This errata sheet provides updated information on known device issues affecting Cyclone® IV devices.

Table 1 lists specific Cyclone IV issues and which Cyclone IV devices are affected by each issue.

Figure 1. Programmable PPM Detector Options in the ALTGX MegaWizard Plug-In Manager

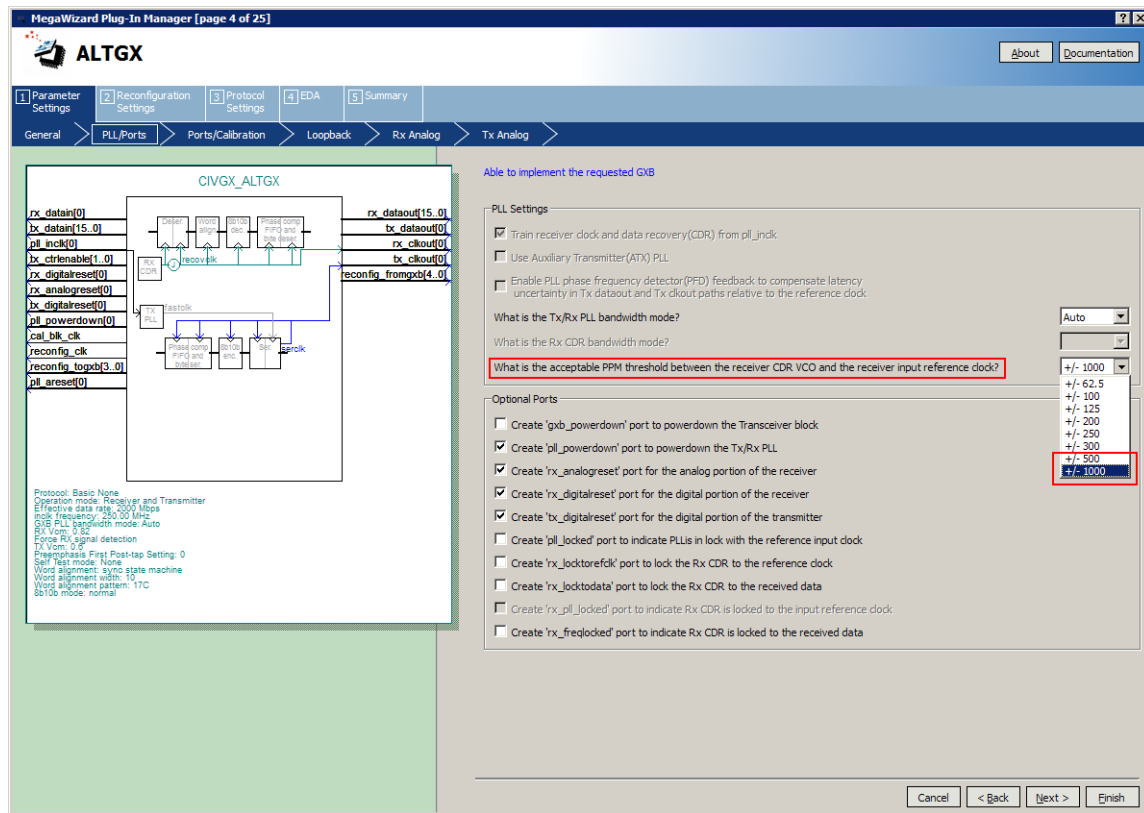
The ± 500 PPM and ± 1000 PPM options for the Programmable PPM Detector feature in the ALTGX MegaWizard™ Plug-In Manager, as shown in [Figure 1](#), are no longer supported in the Quartus II software version 10.0 SP1 and later. These options are removed because the programmed PPM threshold values exceed the receiver CDR PPM tolerance between the upstream transmitter reference clock and the local receiver reference clock.

Designs compiled with the Quartus II software version 10.0 and earlier may have a link failure risk when the receiver is operating in a system that has ± 500 PPM or ± 1000 PPM differences for the reference clock frequencies between the upstream transmitter and the local receiver. Using CDR Manual Lock mode does not overcome the link failure risk.

For a receiver design that has the ± 500 PPM or ± 1000 PPM options selected in the Programmable PPM Detector feature, Altera recommends evaluating the system operation with different options, ranging between ± 62.5 PPM and ± 300 PPM. To change the **Programmable PPM Detector** option, regenerate and recompile the ALTGX MegaWizard Plug-In Manager design file with the supported options.

If you compiled your designs using a Quartus II software version prior to 10.0 SP1, and you have selected the ± 500 PPM or the ± 1000 PPM option for the Programmable PPM Detector feature, the Quartus II Analysis and Synthesis error will be reported in the Quartus II software version 10.0 SP1 and later.
